# Access Compliance Report

### (Curb Ramps)

Intersection ID: 13639	Main Street: BRIAR_CREEK_RD	Cross Street: CENTRAL_AV	Location: NE
ADA ID: 06D266EDCD7A	Ramp Type: Perp	Initial Pass/Fail: Fail	Overall Compliance: No
Severity Score: 21.25			
Codes/Mitigation Info/Possible Solution		Field Measurements/Component Compliance

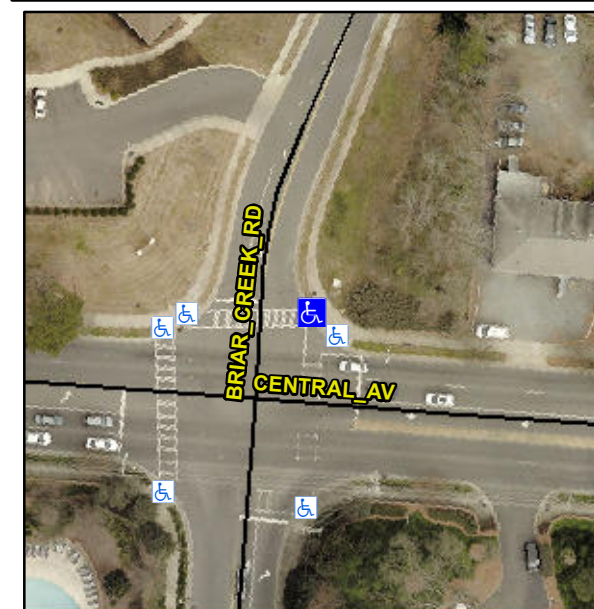
**Not Found, R304.5.1, R304.5.3**

Compliance	Description	Data	Compliance	Description	Data
N/A	Ramp Length (in)	48.5	Yes	Ramp Slope (%)	6.3
No	Ramp Width (in)	46.5	No	Ramp XSlope (%)	6.3
N/A	Flare Type LT	N/A	N/A	Flare Type RT	N/A
N/A	Flare Slope LT (%)	N/A	N/A	Flare Slope RT (%)	N/A
N/A	Flare Traversable LT?	N/A	N/A	Flare Traversable RT?	N/A
N/A	Landing Length (in)	N/A	N/A	DWS Provided?	N/A
N/A	Landing Width (in)	N/A	N/A	DWS Contrast?	N/A
N/A	Landing Slope (%)	N/A	N/A	DWS Length (in)	N/A
N/A	Landing X Slope (%)	N/A	N/A	DWS Full Width?	N/A
N/A	Landing Curb? (Y/N)	N/A	N/A	DWS Offset (in)	N/A
N/A	Shared Landing?	N/A			
N/A	Gutter Ponding?	N/A	N/A	Gutter Slope (%)	N/A
N/A	Gutter Lip Ht (in)	N/A	N/A	Gutter X Slope (%)	N/A
N/A	Painted X Walk1?	Yes	N/A	Painted X Walk2?	N/A
	X Walk 1 Direction	To W		X Walk 2 Direction	N/A
N/A	X Walk 1 Width (in)	100.0	N/A	X Walk 2 Width (in)	N/A
	X Walk 1 Slope (%)	1.4		X Walk 2 Slope (%)	N/A
	X Walk 1 X Slope (%)	5.7		X Walk 2 X Slope (%)	N/A

**Remove & Replace Entire Ramp.**
